Code Test & Results

Code Test & Results

THE CODE TEST.

Site #4 (SPA1)

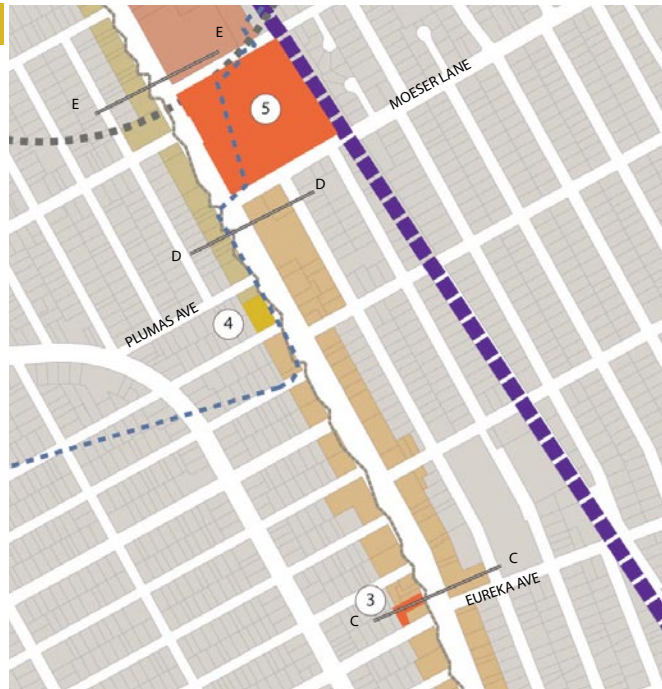
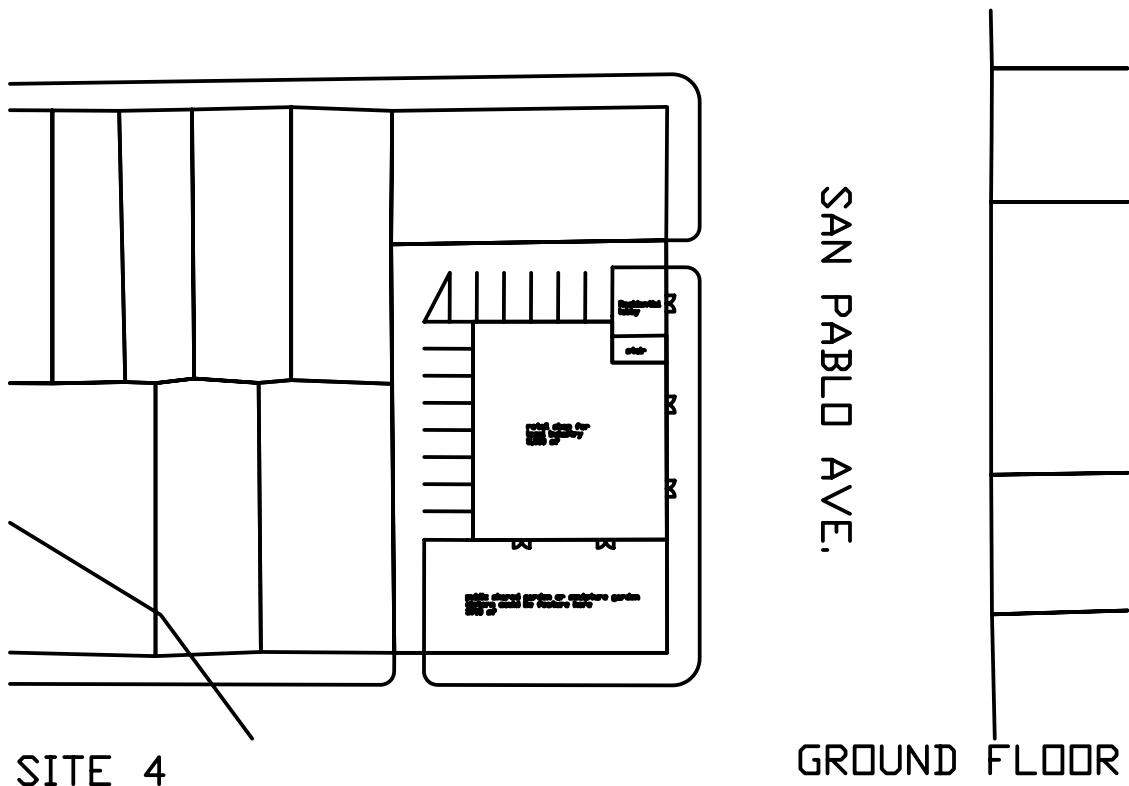
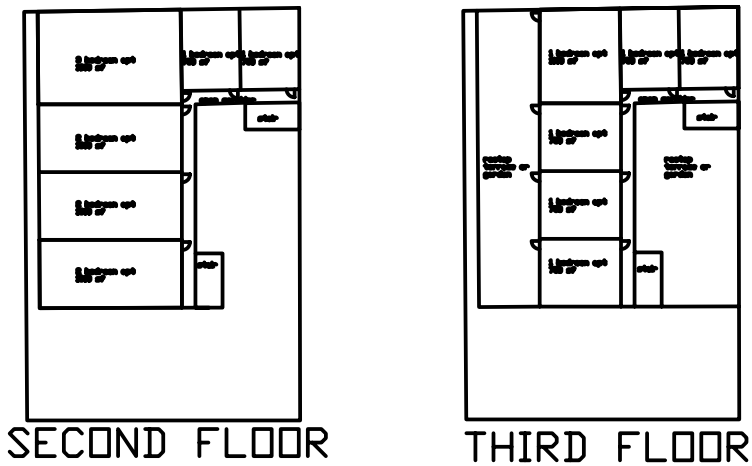
Site #4 code test for the redesign of a northwest corner auto-oriented business parcel does not comply with the following code requirements: incorporation of existing land use, minimum frontage, and unit density. The sun slot setback is not applicable to parcels in SPA1 since the building height is minimized, so the minimum frontage and unit density requirements could have complied if the sun slot setback had not been applied onto the site.

Total parcel sf = 15310sf with 12 units = 34 units/acre (-15%)

Site #6 (SPA1)

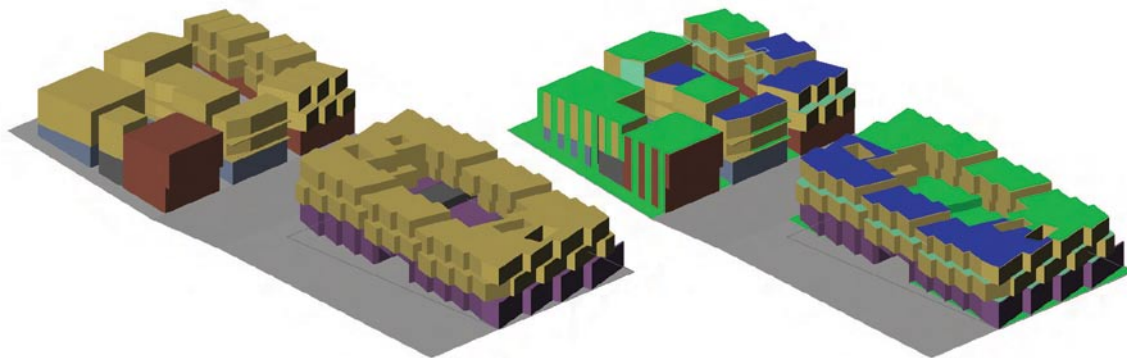
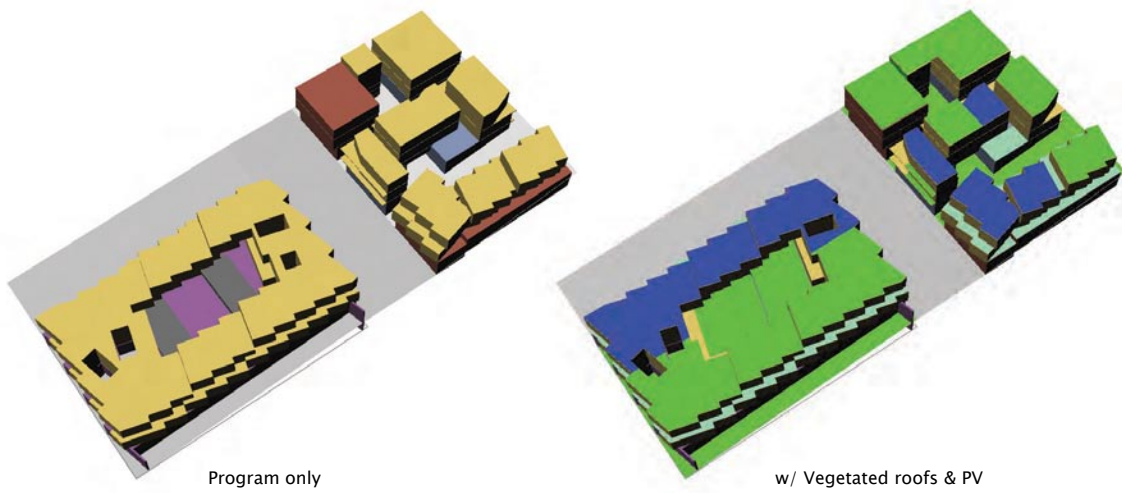
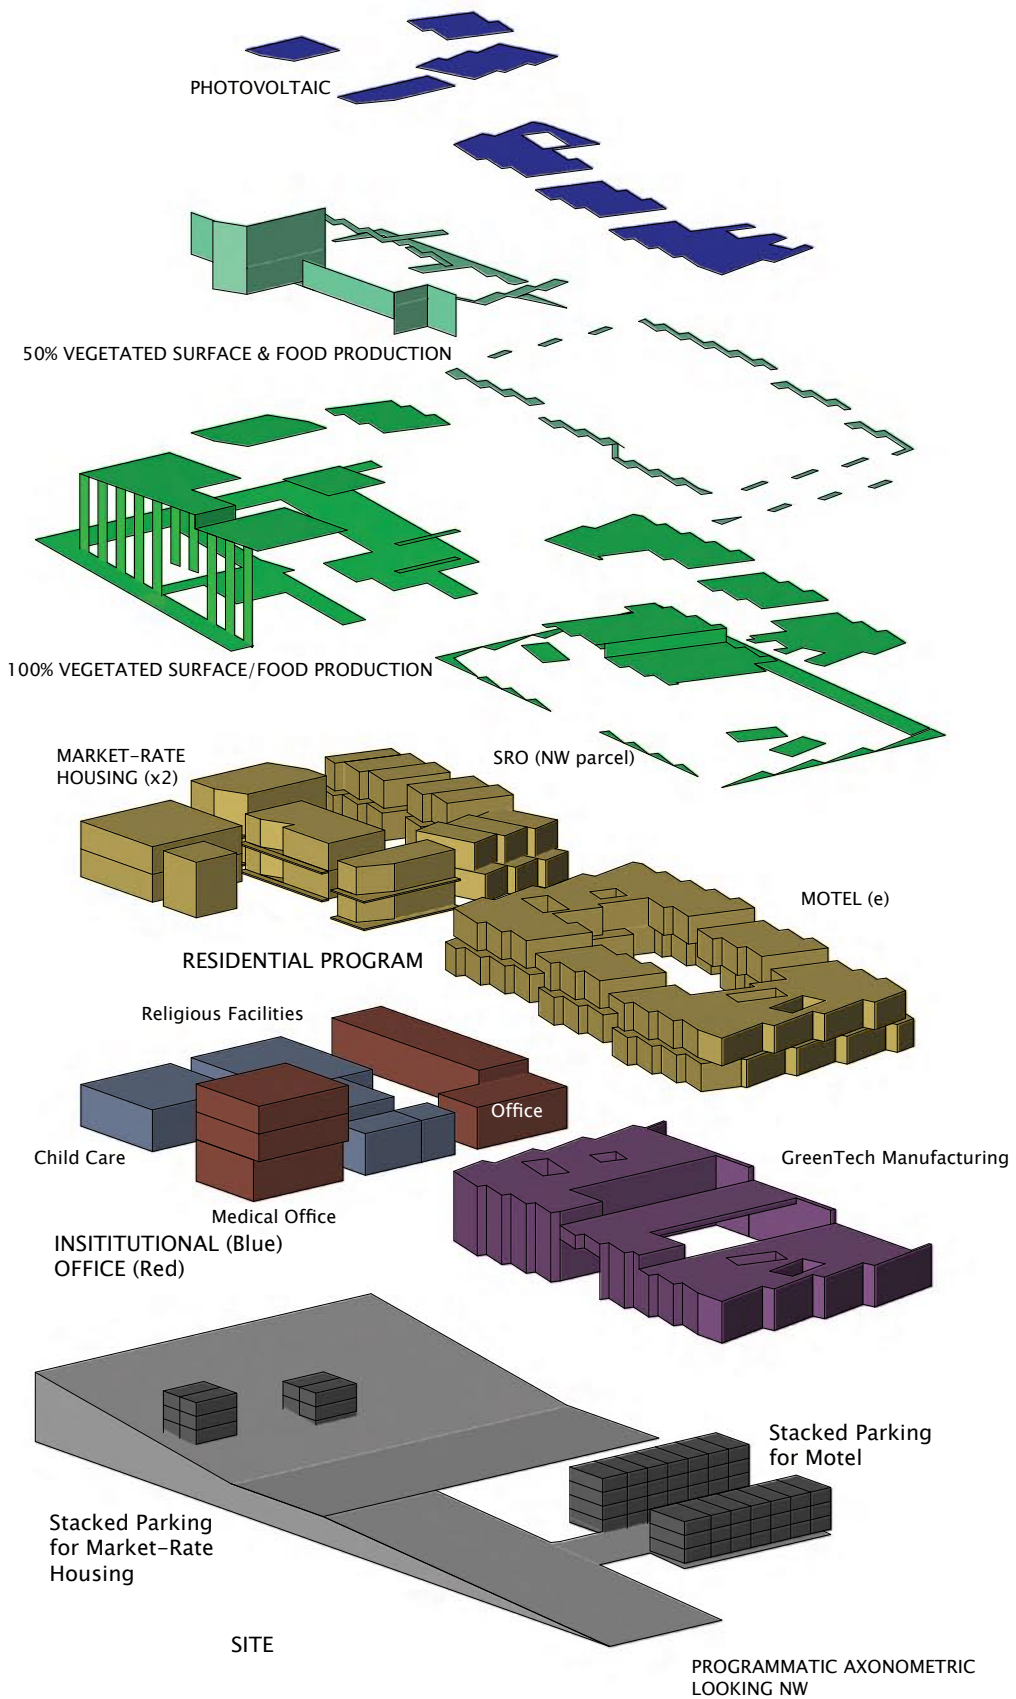
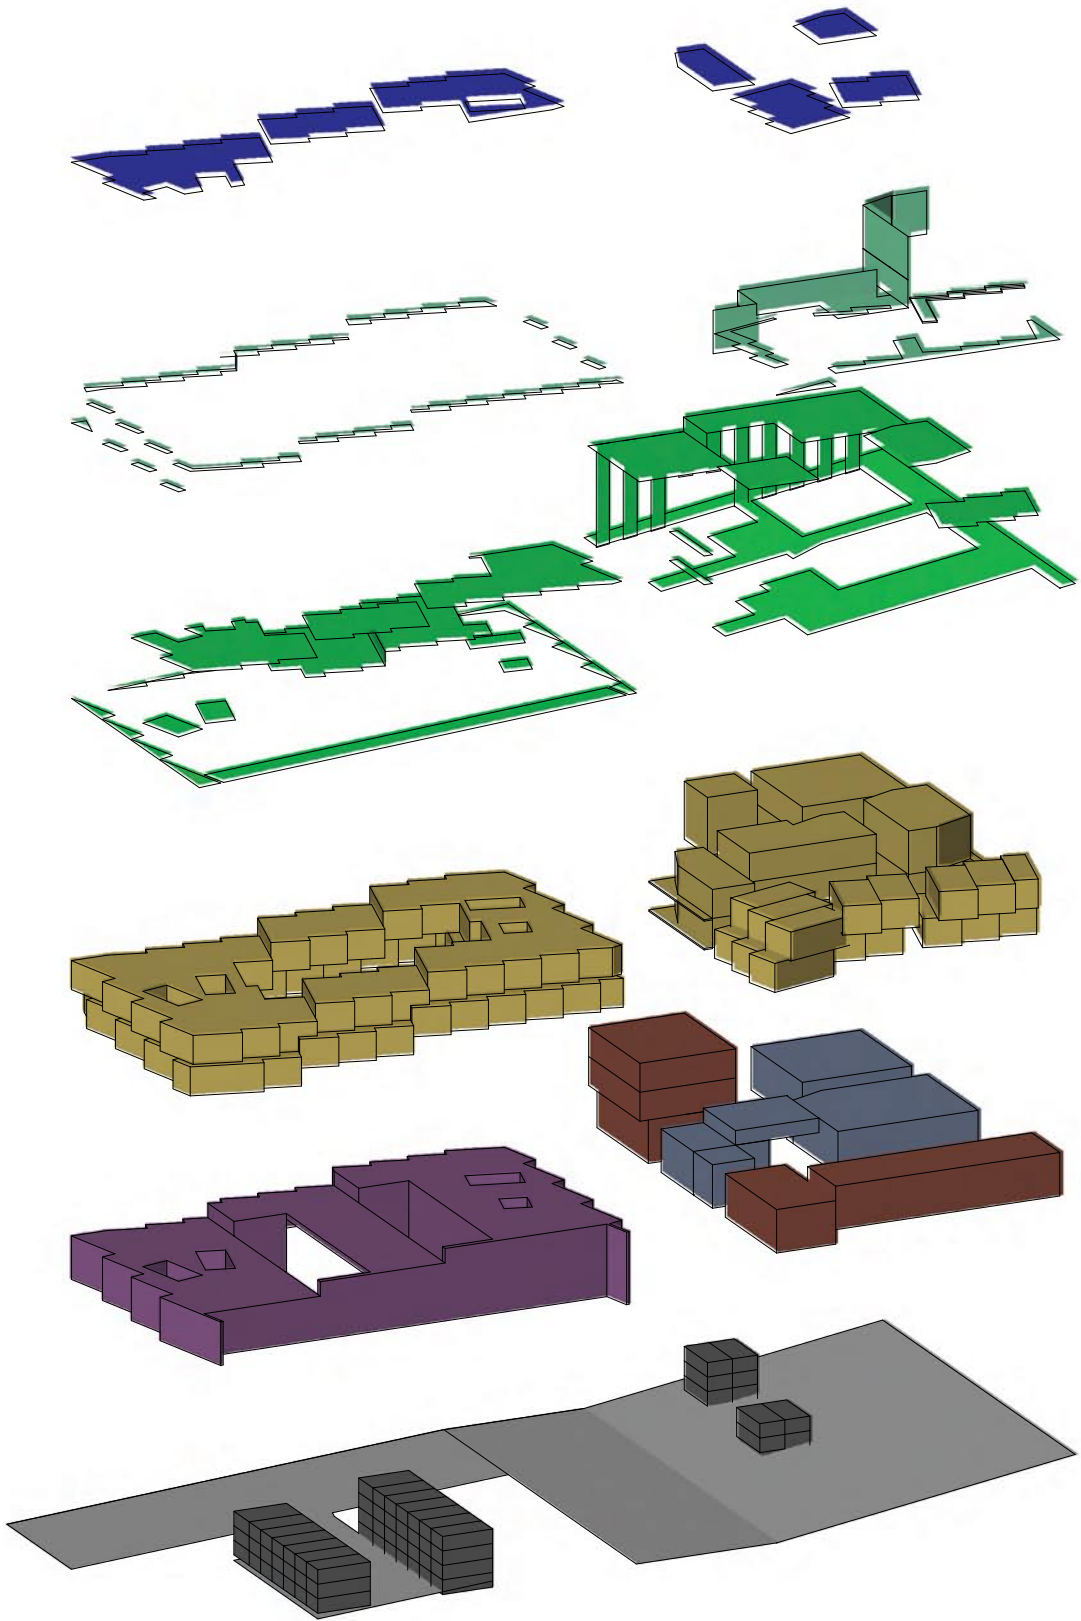
Site #6 code test for the redesign of a mid-block motel parcel meets all of the code requirements, except the stormwater standard, but exceeds the density requirement (actual 74 units/acre) by 85% including multi-family residential units, a motel, and a single resident occupant (SRO) facility. The designer introduced a new right-of-way since the existing site required subdivision into at least three parcels and the proportions of the parcel were not conducive to subdivision perpendicular to San Pablo Avenue.

Site #7 (SPA3)

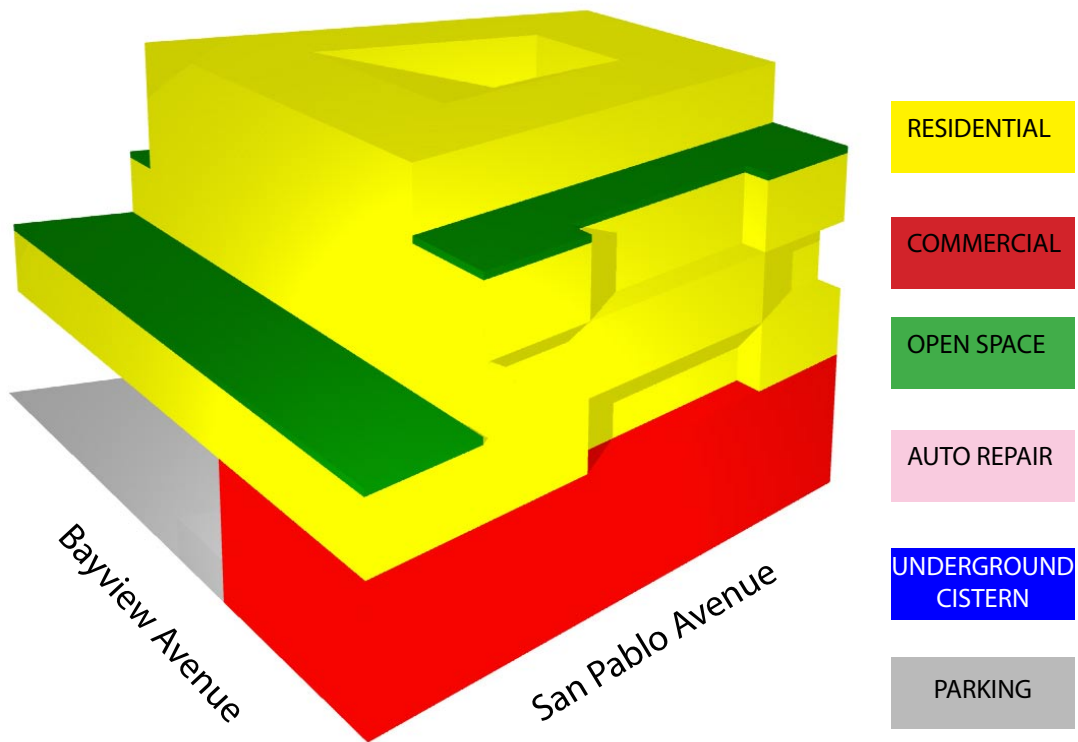
Site #7 code test for the redesign of a northwest corner auto-oriented business parcel meets all of the code requirements, and exceeds the density requirement (actual 63 units/acre) by 5%. The designer relocated the auto-related business to the back of the parcel where the stacked parking can be shared by the residents and the auto-repair business.

Site #11 (SPA3)

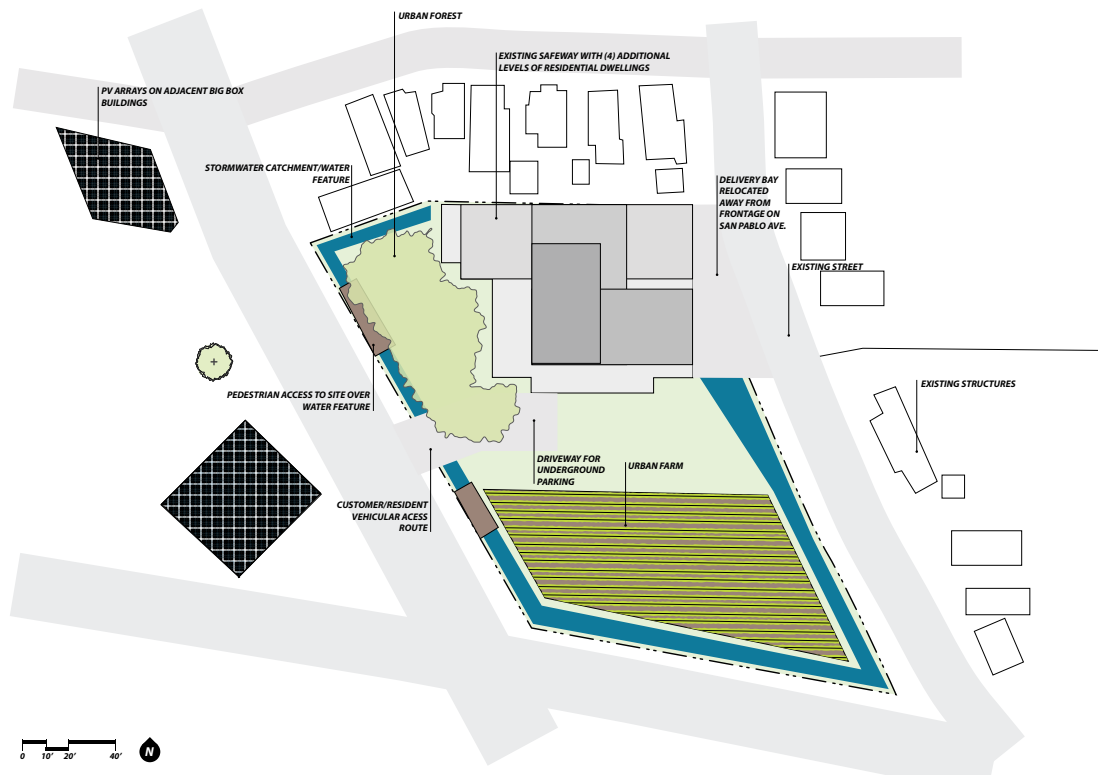
Site #11 code test for the redesign of a northeast corner grocery store parcel does not comply with most of the code requirements. The design does retain the existing Safeway grocery store and its structure and then adds a significant open space for agricultural production. The residential units were estimated at 32 units, which amounts to 21 units/acre if the parcel is subdivided into two parcels. 21 units/acre represents only 35% of the minimum density zoned for the site.

Site #12 (SPA3)

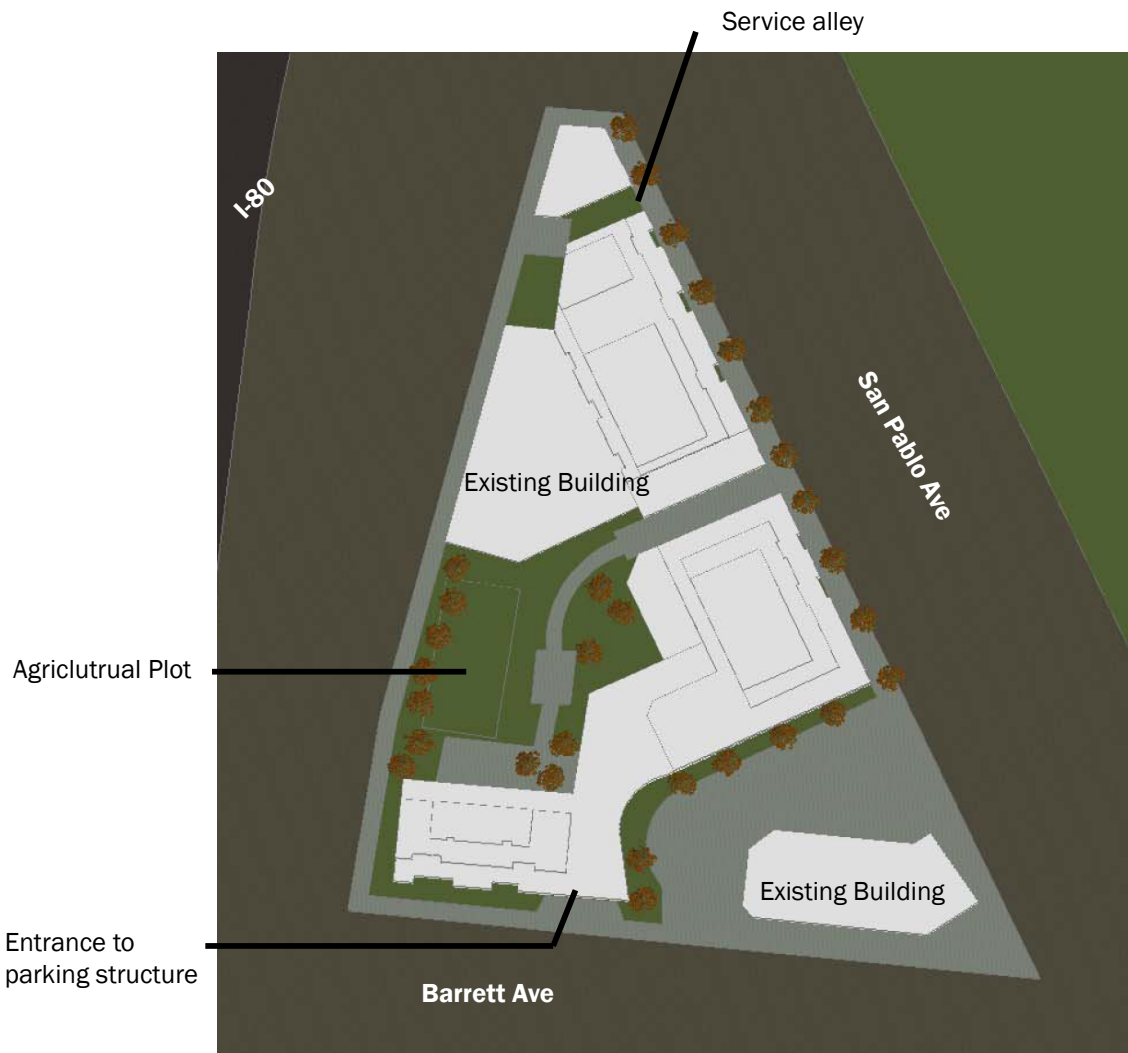
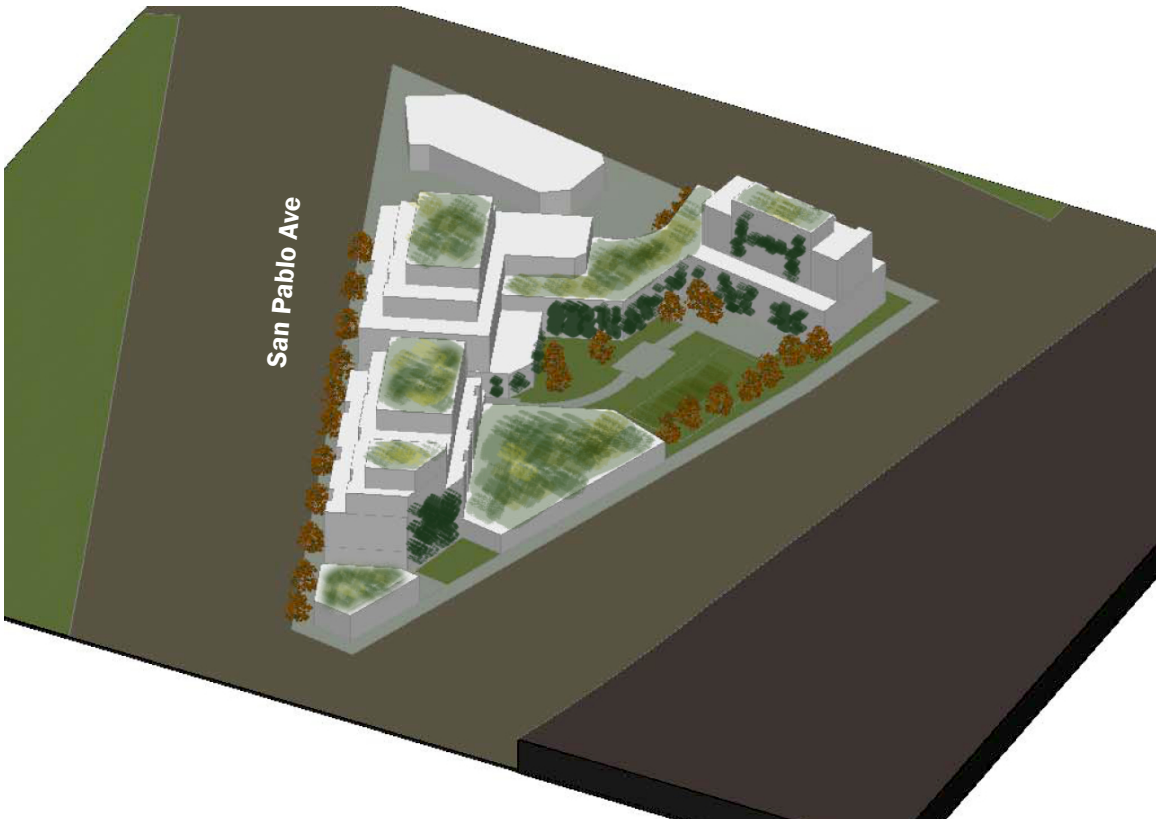
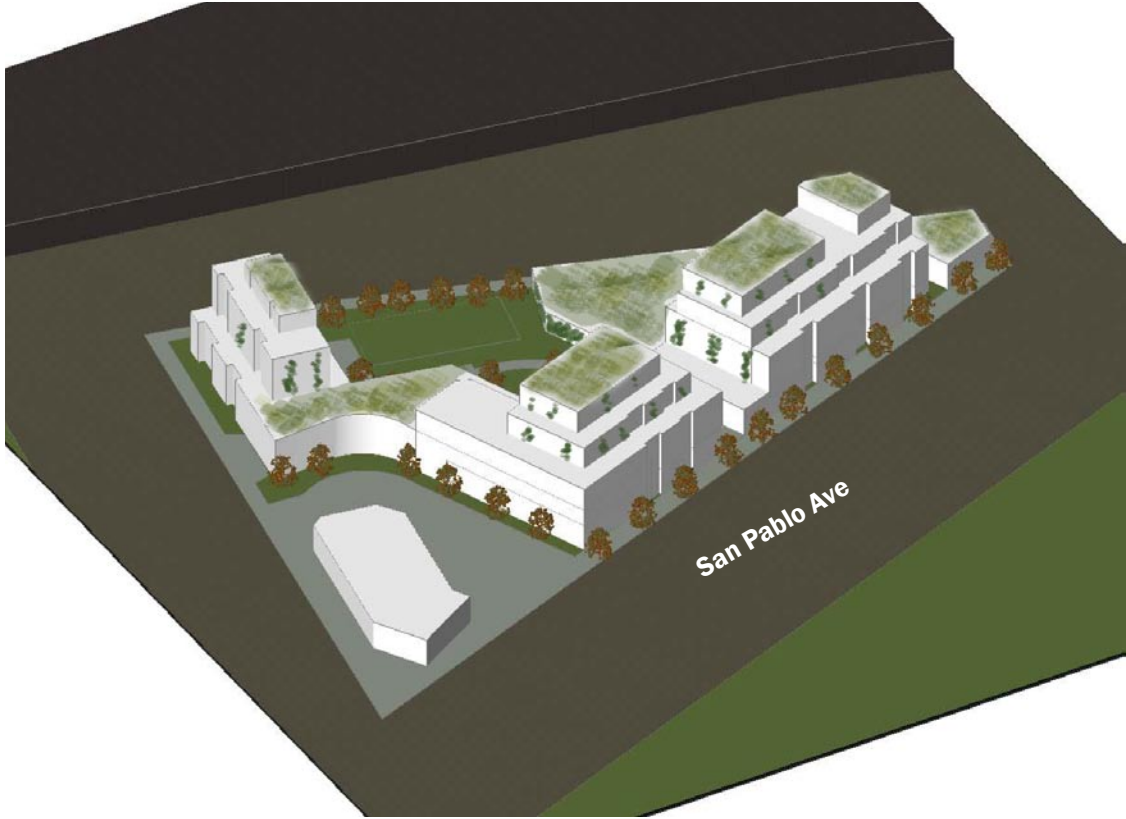
Site #12 code test for the redesign of a large commercial/retail parcel meets all of the code requirements including density, except for the sun slot standard and the stormwater standard.
